**Metcalf & Eddy**

July 18, 2008

**Subject: Supplemental Submittal to Environmental Notification Form (ENF) for  
Flood Mitigation Facilities for the Peabody Square Area  
EOEEA # 14251**

**FIGURE 1**  
**TYPICAL CROSS-SECTION OF NORTH RIVER WITH SLOPED CHANNEL**

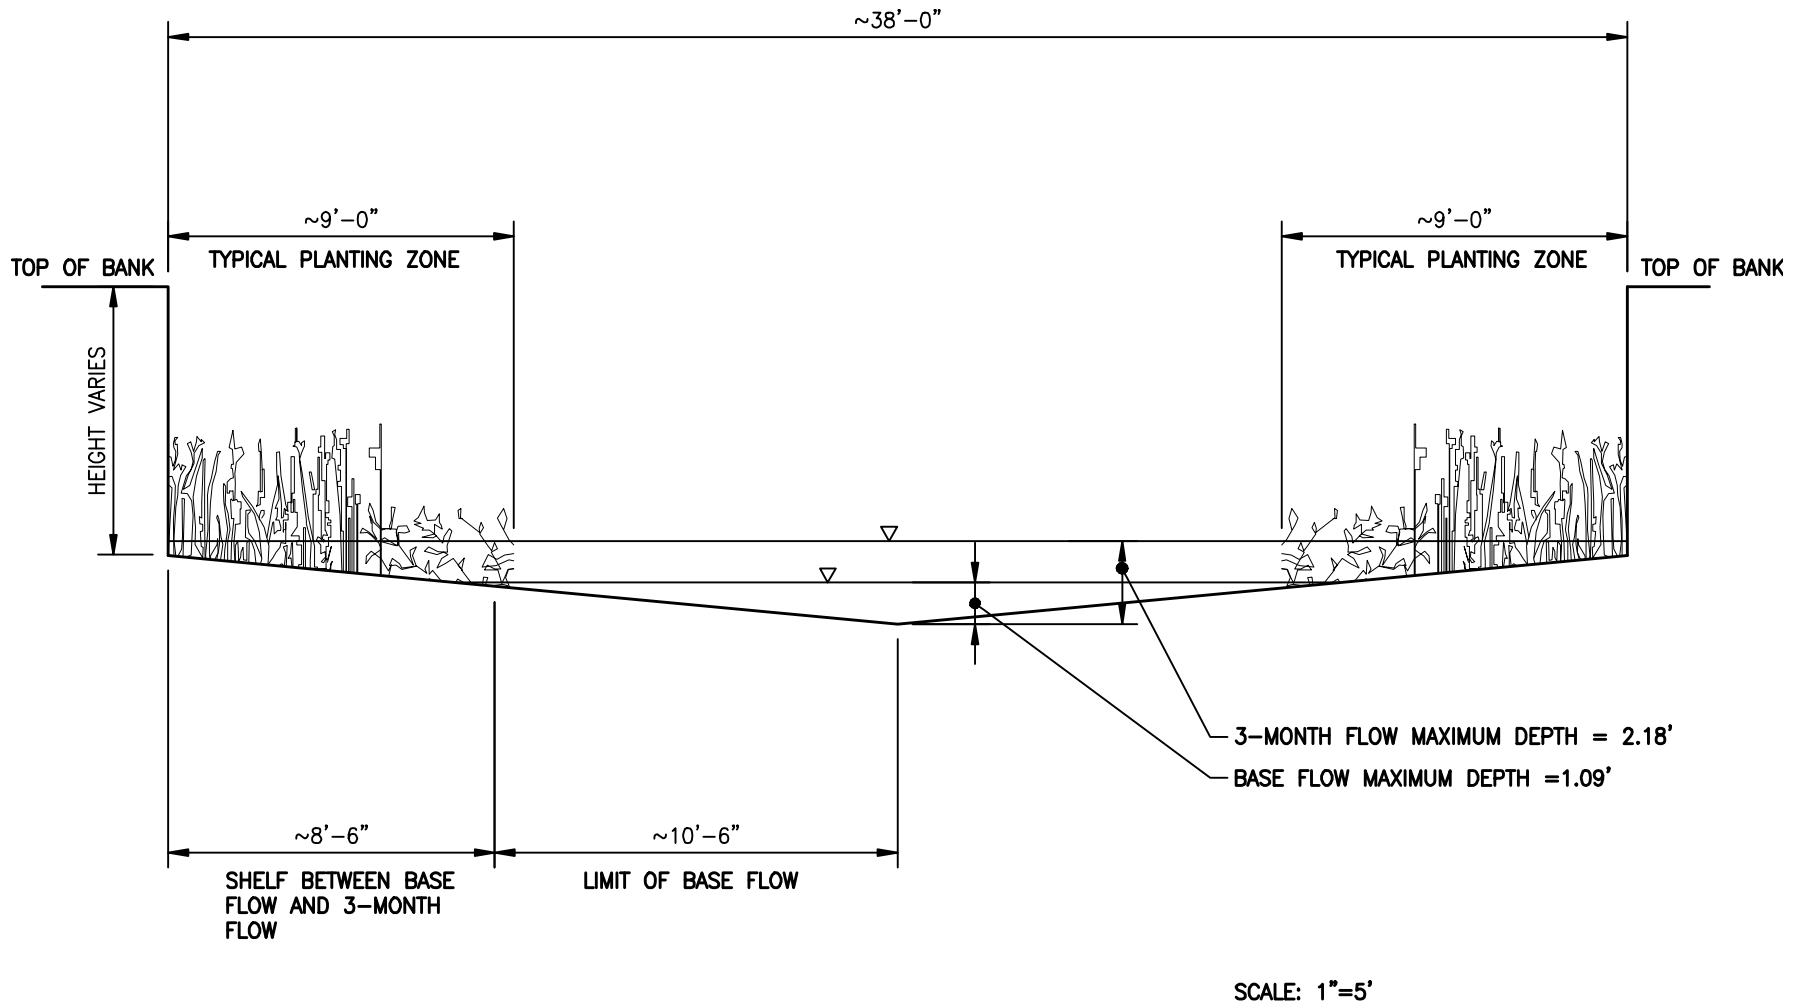
2. Will widening the North River canal increase the channel's width/depth ratio and negatively affect low flow conditions? Could this change also decrease the sediment transport capacity of the channel resulting in subsequent aggradation of sediment in the channel?

The North River canal upstream of Howley Street has an existing width that varies between approximately 11 to 22 feet. The existing average base flow depth for this reach of the North River is approximately 1.1 feet, resulting in an average width/depth ratio of approximately 17:1 during base flow conditions. As described in the ENF and presented in the PDR, under Project 2, this reach of the North River canal is proposed to be widened to a consistent width of 38 feet, using the vertical south wall alternative. The widened channel bottom in the PDR is proposed to be level/flat. The new average base flow depth for this reach would be approximately 0.5 feet, resulting in a new average width/depth ratio of approximately 76:1.

In order to minimize changes to the width/depth ratio of the North River and address associated concerns raised in the comment, the City has evaluated alternative designs for channel widening. An alternative channel design consisting of a sloped channel was reviewed for the Project 2 area. A typical cross section of the sloped channel is presented in Figure 1. A slope of 10 horizontal to 1 vertical was chosen to minimize erosion. Hydraulic modeling was performed to determine flow depth and velocity during key periods including base flow (dry period between storms), 3-month storm, and 50-year storm. The resulting average width/depth ratio for base flow is approximately 20:1, which is very close to the existing condition of 17:1. In addition, the base flow velocities for the sloped alternative are very similar to the existing base flow velocities. Thus, the sloped channel alternative would result in a narrower channel during base flow with increased velocity as compared to the flat channel, which should limit sediment buildup and benefit water quality and dissolved oxygen. Various features of the proposed configuration of the sloped channel may be improved as part of the final design of Project 2.
